Road Safety Audit Review

Town:	Alburgh	Date Reviewed:	November 2, 2015
Route:	US 2 and VT 78 Intersection	Mile points:	US 2: 6.23, VT 78: 0.0

The location of this RSAR is the intersection of US 2, VT 78 and Truck Route Road in Alburgh.

This RSAR was conducted at the request of Bruce Nyquist, Director of the Office of Highway Safety at the Agency of Transportation in response to recent citizens' complaints.

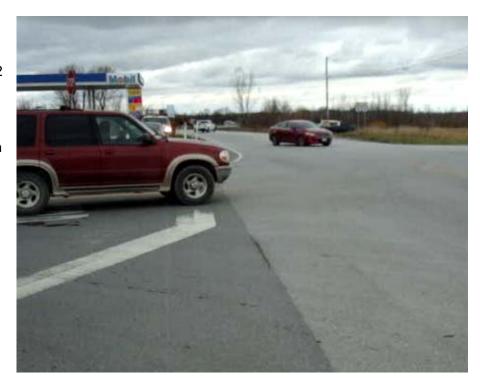
Concern: Corner Sight Distance Issue, Northwest Quadrant

The corner sight distance when stopped on Truck Route Road and looking north, towards US 2 (i.e., when looking to the left) is sometime poor. This is due when vehicles at the gas station are parked between the gas pumps and the raised island. Signage and banners inside of the grass island can also contribute to the visibility issue. These situations are illustrated in the next few pictures.

Safety Enhancements:

The district should enforce any signage obstruction located in the right-of-way and especially in the grass island.

Eliminate the possibility of parking vehicles in the sight triangle by enlarging the grass island.

Note, Intersection Sight Distance (ISD) on the diagram to the right, for 40 mph, is 445 feet as per AAHSTO.
